Date: June 9, 2011  
From: CIET  
Subject: Modification of Cascadia Deployment Plan

The purpose of this memo is to seek advice regarding a change in the Year 1 Cascadia Initiative deployment plan.

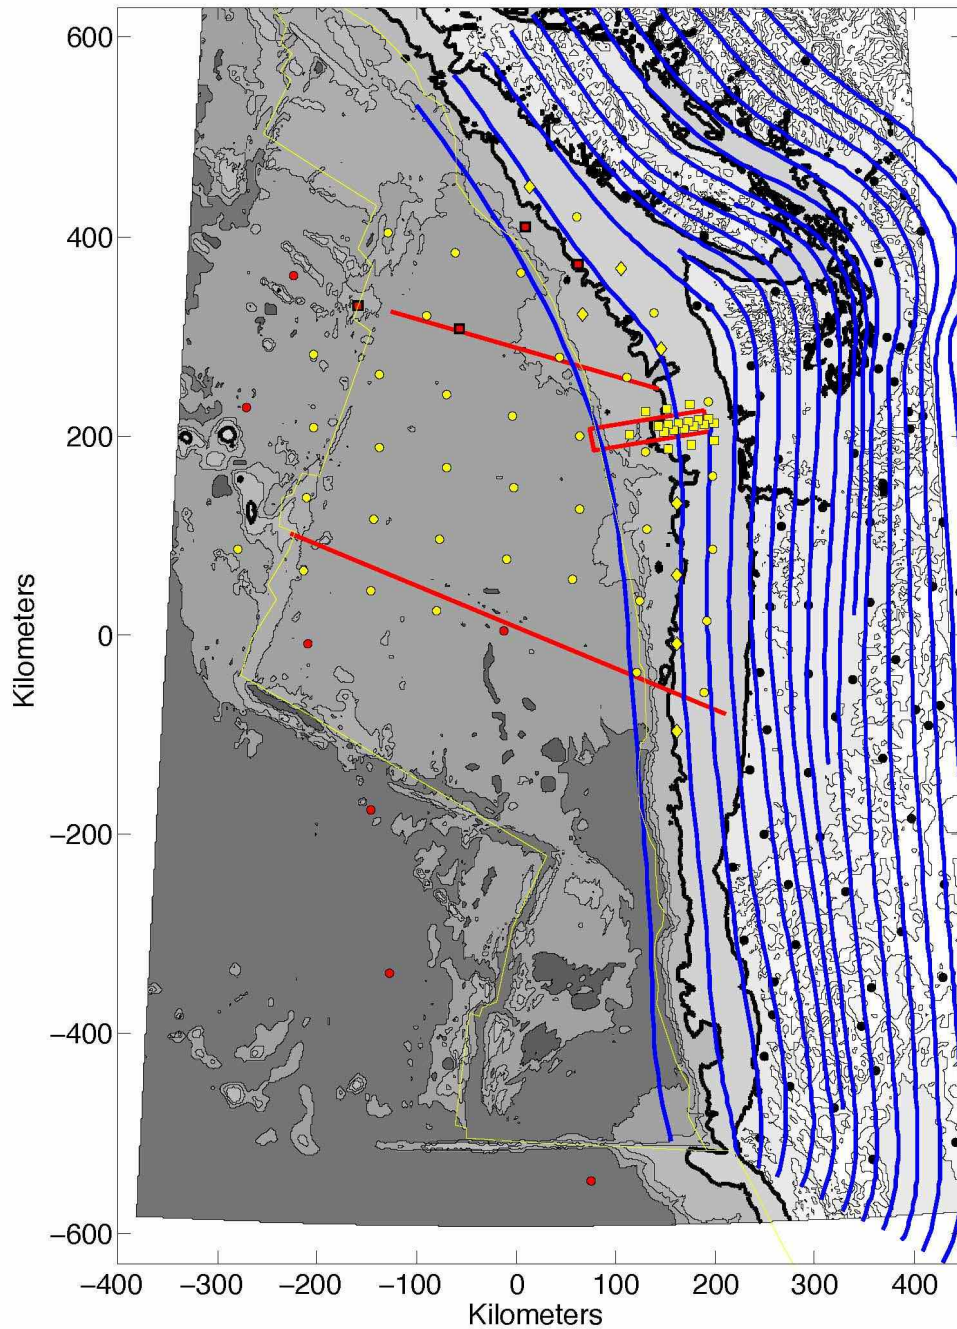
This change in instrument availability requires a change in the deployment plan as discussed at the Portland meeting in 2010 and presented in the workshop report<sup>1</sup>. The TRM OBSs are only suitable for deployment in water depths less than 1000 m. Fig. 1 shows the Year 1 deployment plan from the Portland workshop. Removal of 10 OBSs from the Year 1 deployment plan by necessity impacts either the Northern Focused Array (FA) off of Grays Harbor (yellow squares, Fig. 1) or the along-strike coverage and monitoring of the forearc.

Figure 2. Proposed modification of the Northern FA. 10 sites have been removed at water depths less than 1000 m, which is the maximum water depth for a TRM OBS deployment. Second bold contour line out from coast is 1000 m.

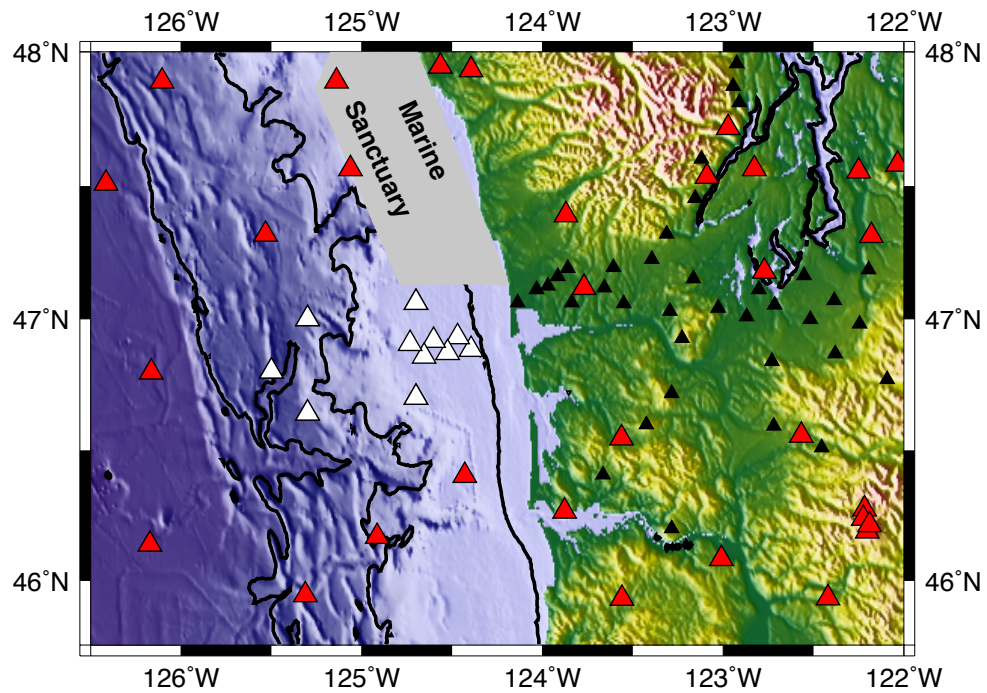
In view of the above, the CIET proposes the following modification to the Year 1 deployment plan. A total of 10 instruments from the Northern Focused Array will be assigned a lower priority for deployment in 2011 (i.e., unless we get lucky, these 10 OBS will not be deployed this year). Figure 2 shows a revised deployment plan in the vicinity

of the Northern FA under the assumption that 10 TRM OBSs are available and that 2 of these 10 instruments are targeted for monitoring along the shelf (see Fig. 3). A staggered configuration has been maintained in the Northern Focused Array and sites closer to the shoreline (where the thrust interface is deeper) are retained. If this general plan is approved, minor adjustments to site location will be made to achieve uniformity of spacing along the forearc and to take into consideration bathymetry, trawling activity and geo/bio-hazards. The proposed changes do not adversely affect the monitoring of the forearc and the data to be collected by the Northern FA will provide a good opportunity to evaluate the potential of the receiver function method in shallow water environments.
